Summary Reviews of Select Aspects of the USEPA Upper Hudson River Models

**Presented to the USEPA Baseline Modeling Report Peer Review Members
March 27, 2000**

**Quantitative Environmental Analysis, LLC
Montvale, NJ 07645**

Figure 2. Total discharge and sediment loads input to tributaries in Schuylerville - Stillwater reach.

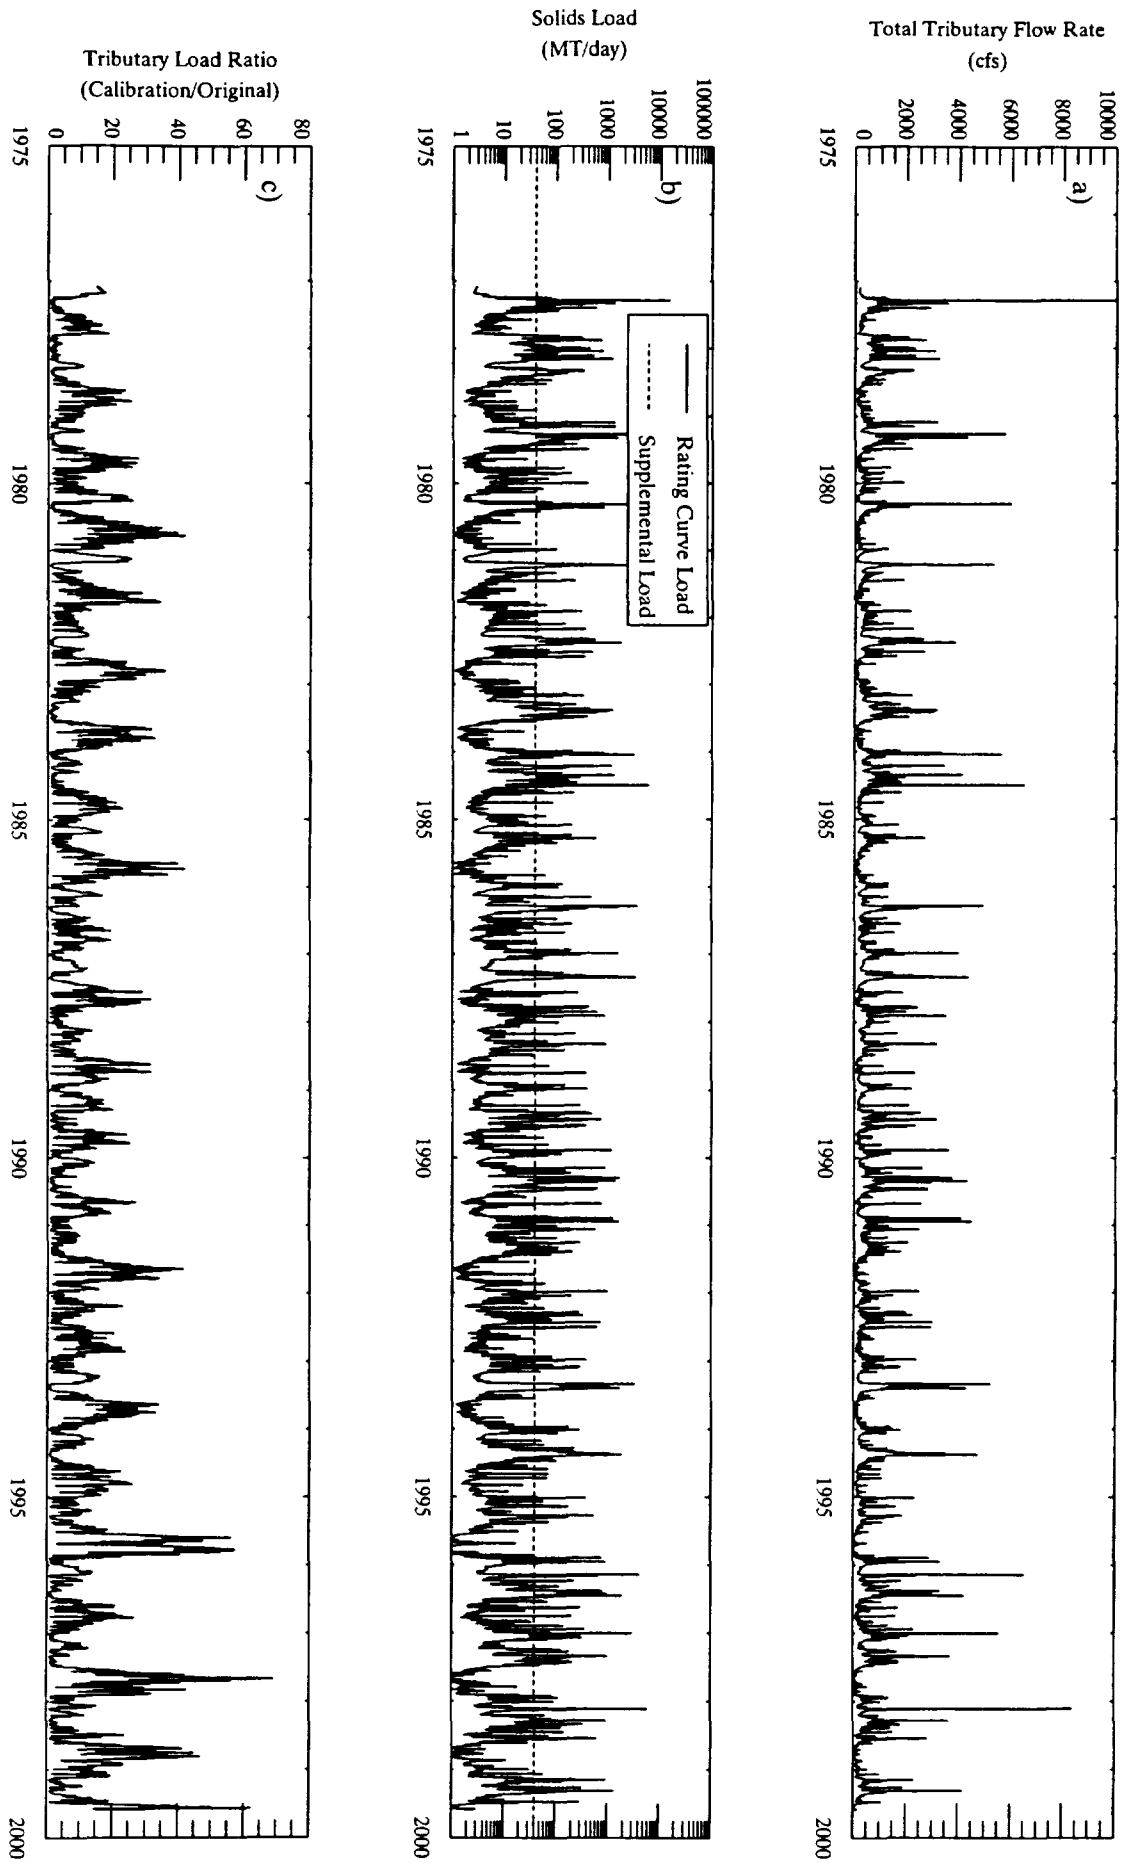
To calibrate its model, USEPA adjusted solids loadings from the tributaries downstream of the TIP (USEPA 2000), especially during low-flow conditions. Unfortunately, the RBMR does not provide sufficient information to determine the cause and extent of the initial calibration difficulties. Thus, USEPA input an additional tributary solids load of 40 metric tons/day (MT/day) to both the Schuylerville-Stillwater and Stillwater-Waterford reaches during the final calibration. Although USEPA portrays this load increase as being within the uncertainty range of the estimated tributary loads (USEPA 2000), a closer examination reveals that the magnitude of the supplemental solids loading was not trivial during low-flow periods, i.e., below mean tributary flow rate. While the increase in long-term solids loading was about 26 and 17% for the two reaches, respectively (USEPA 2000), the relative increase in tributary solids loading was much greater during low-flow conditions. Figure 2b shows a temporal comparison of the tributary loading for the Schuylerville-Stillwater reach specified by: 1) time-variable rating curves (developed from the solids load analysis referenced above and used during initial model calibration) and 2) constant load of 40 MT/day. During low-flow conditions, the supplemental load is significantly greater than the original rating curve load. The magnitude of this disparity in the Schuylerville-Stillwater reach is illustrated in Figure 2c, which shows the temporal variation of the ratio of the final calibration rating curve loading (initial rating curve load plus supplemental load) to the initial rating curve loading. This ratio increases as the flow decreases, with maximum values of about 70X and 12X for the Schuylerville-Stillwater and Stillwater-Waterford reaches, respectively. The ratio is greater than two 83% of the time between 1977 and 1999 for the Schuylerville-Stillwater reach. Assuming that uncertainty about the rating-curve-estimated loading is about a factor of two, then this percentage represents the portion of

time during which the assumption of a constant supplemental solids loading of 40 MT/day is **not** within the assumed uncertainty range of the tributary solids loading.

Figure 3. Comparison of supplemental load effects to original rating curve and TIP tributary data for direct drainage area in Schuylerville - Stillwater reach. Flow rates are normalized with respect to mean flow in tributary.

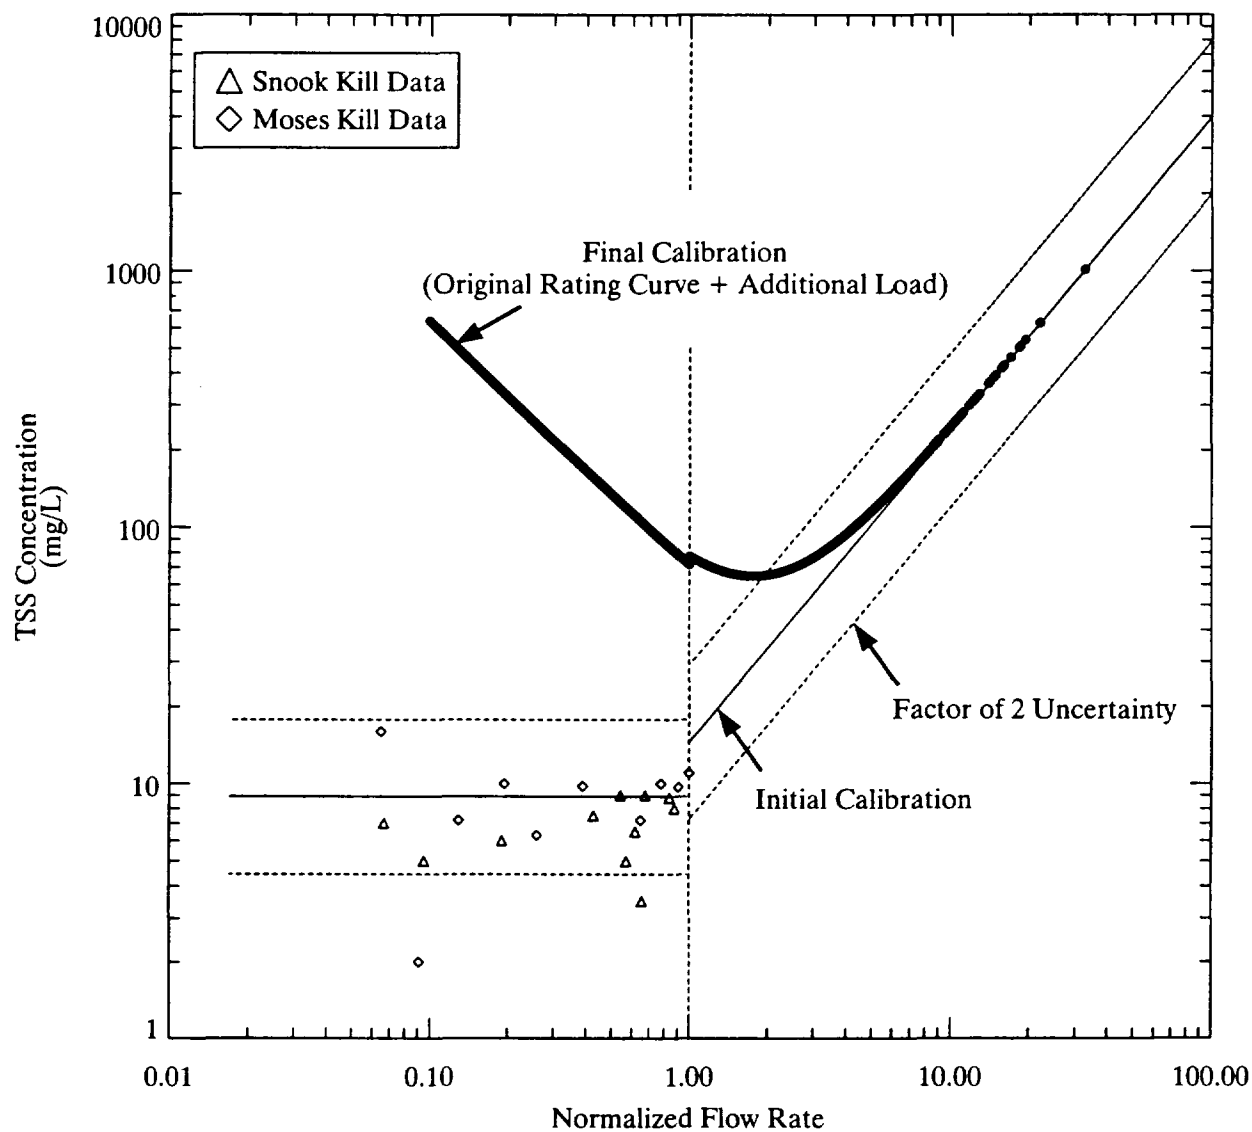
Analysis of tributary TSS concentrations required to produce an additional load of 40 MT/day provides a further illustration that this loading was unrealistic during low-flow conditions. With the additional load, low-flow TSS concentrations were as high as 500 and 190 mg/l for the Schuylerville-Stillwater and Stillwater-Waterford reaches, respectively. These concentrations are much higher than observed TSS concentrations during low-flow periods for UHR tributaries. Further illustration of the unrealistically high TSS concentrations resulting from the additional tributary load is presented on Figure 3 for the direct drainage area in the Schuylerville-Stillwater reach. This figure shows TSS concentration as a function of flow rate determined from three sources: 1) original rating curve (with factor of two uncertainty range); 2) additional constant load (18 MT/day for this tributary); and 3) low-flow TSS data for Snook and Moses Kill. Clearly, the additional load produced unrealistically high TSS concentrations during low-flow conditions.

Figure 2. Comparison of FISHRAND calibration results for largemouth bass presented in the Original and Revised Baseline Modeling Reports.

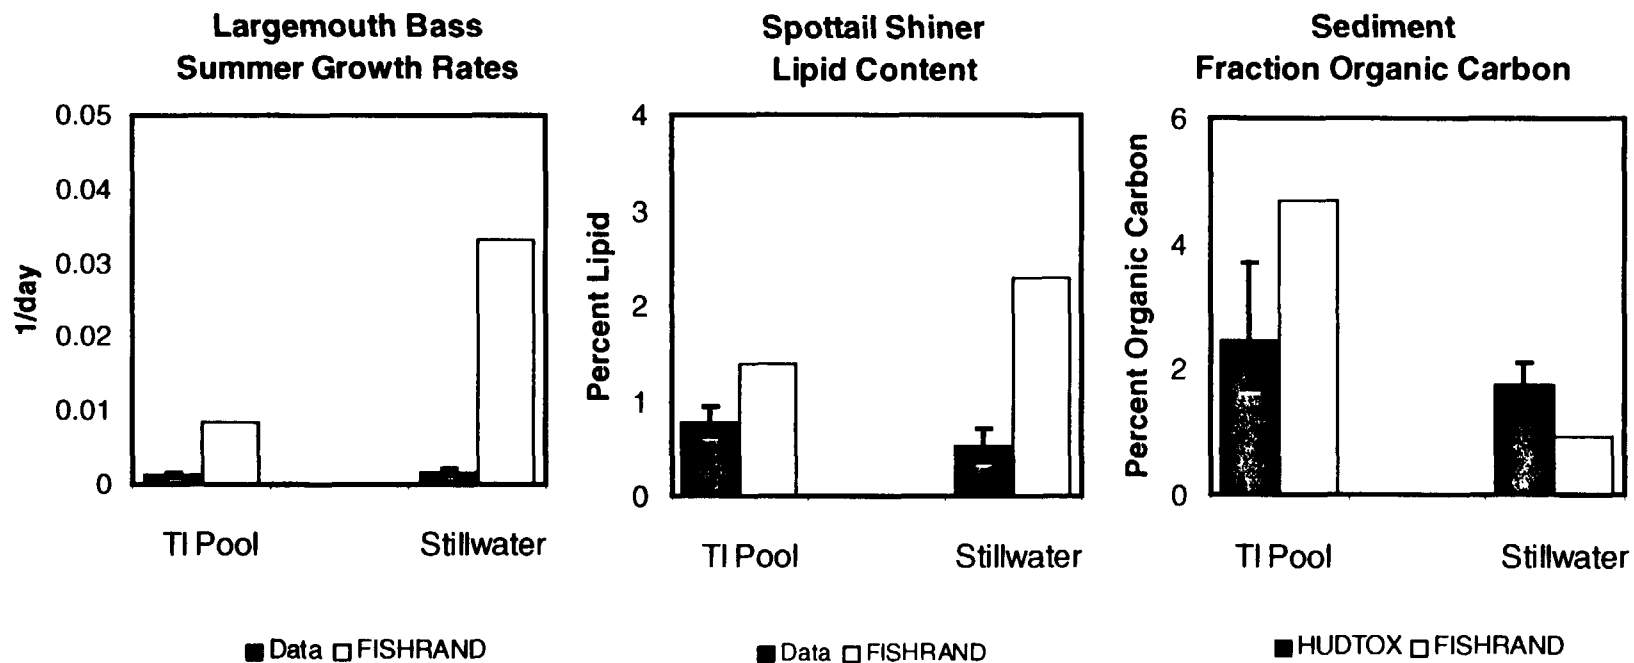
Revised Baseline Modeling Report (RBMR) demonstrate the impact these differences have on model results. Calibration simulations from the BMR and the RMBR are presented in Figure 2. In the original BMR calibration, predicted PCB concentrations in largemouth bass in Thompson Island Pool and Stillwater were similar. In contrast, in the RMBR, computed largemouth bass levels are lower at Stillwater than in the Thompson Island Pool, and closer to measured PCB levels in Stillwater. The dietary compositions did not change from the BMR to the RBMR and are the same throughout the river. However, as mentioned above, different values were used for several parameters. Thus, the improvement in the calibration was achieved by changing the process of bioaccumulation and the bioavailability of PCBs in these two locations, in ways for which there is no support. As a result, both the degree of bioaccumulation and the relative importance of sediment and water column PCB to the food web appear to be incorrect. This means that projected fish PCB levels are likely to be incorrect.

Figure 1. Comparison of fish growth rates, fish lipid content and sediment organic carbon contents used in FISHRAND with measured values.

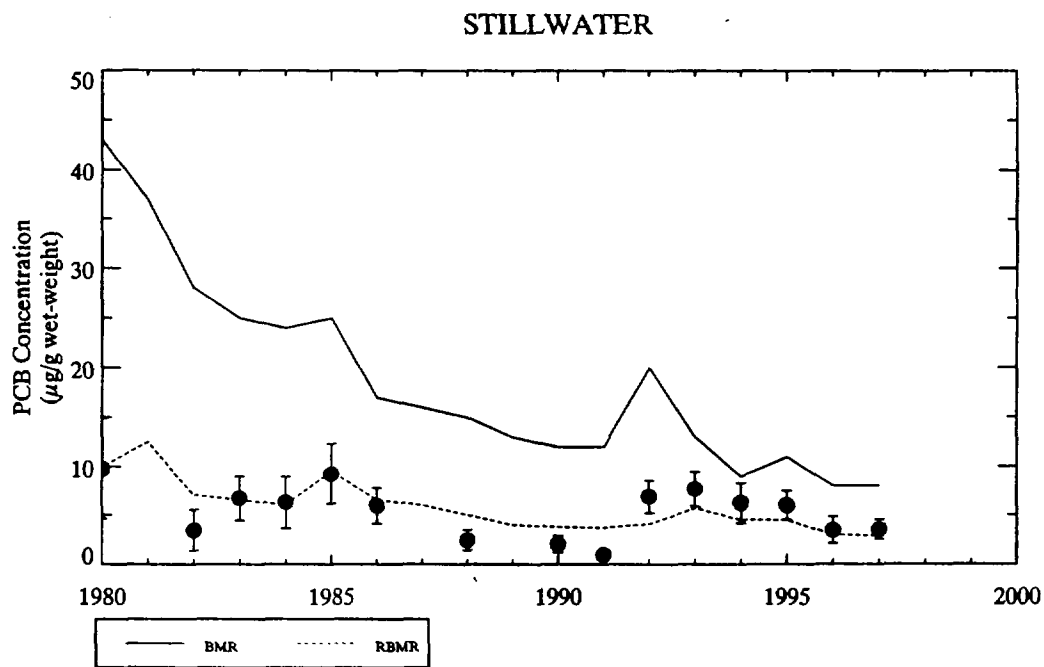
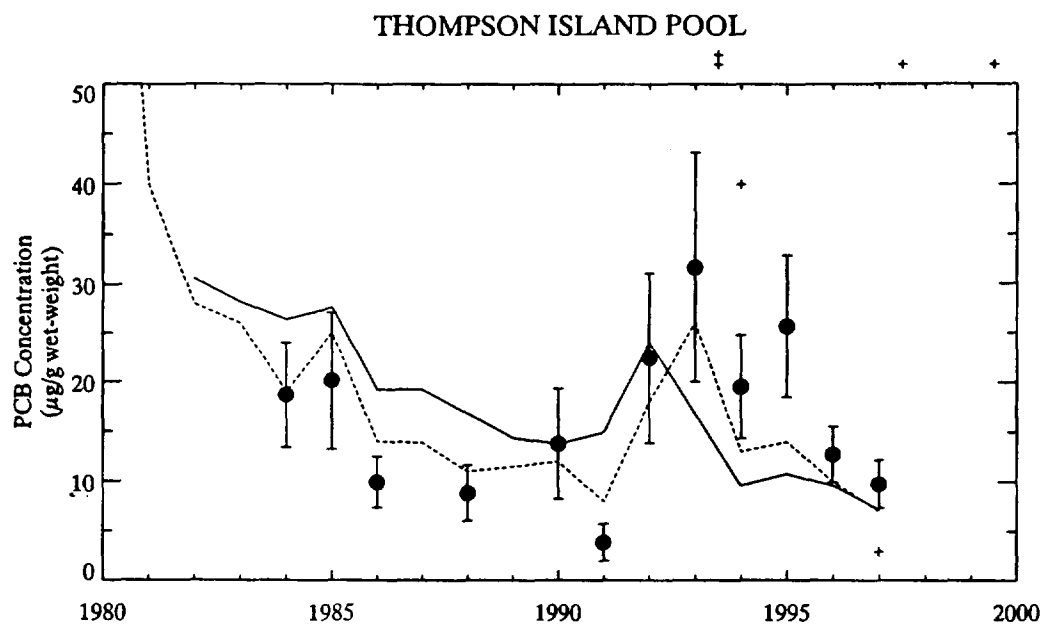
There are three problems with USEPA's estimation of fish lipid contents. First, calibration resulted in lipid contents different from the best estimates based upon the data collected by NYSDEC in during their PCB monitoring program. For example, the fraction lipid in the largemouth bass used at Stillwater (geometric mean = 0.006 g lipid/g wet weight) is less than ½ of the mode of the data (0.014). In contrast, a value more similar to the data (0.011) is used in Thompson Island Pool. Lipid contents for the other modeled species are also modified independently of the data and independently for each reach, for example spottail shiner (Figure 1).

The organic carbon contents of the sediments (f_{OC}) used in the calibrated model differ from the values used in HUDTOX, which are based upon the 1991 GE sediment data (Volume 2D, Book 1, p. 109; Book 2, Table 6-32). The f_{OC} values used in Thompson Island Pool and Stillwater are approximately twice and $\frac{1}{2}$ the average values used in HUDTOX, respectively (Figure 1). Using a lower carbon content at Stillwater increases the carbon-based PCB concentration, resulting in greater accumulation throughout the food web and a greater contribution of sediment-based PCBs to the food web. In effect, PCBs in Thompson Island Pool and Stillwater sediments are assumed to be $\frac{1}{2}$ and twice as bioavailable as the organic carbon data indicate, respectively.
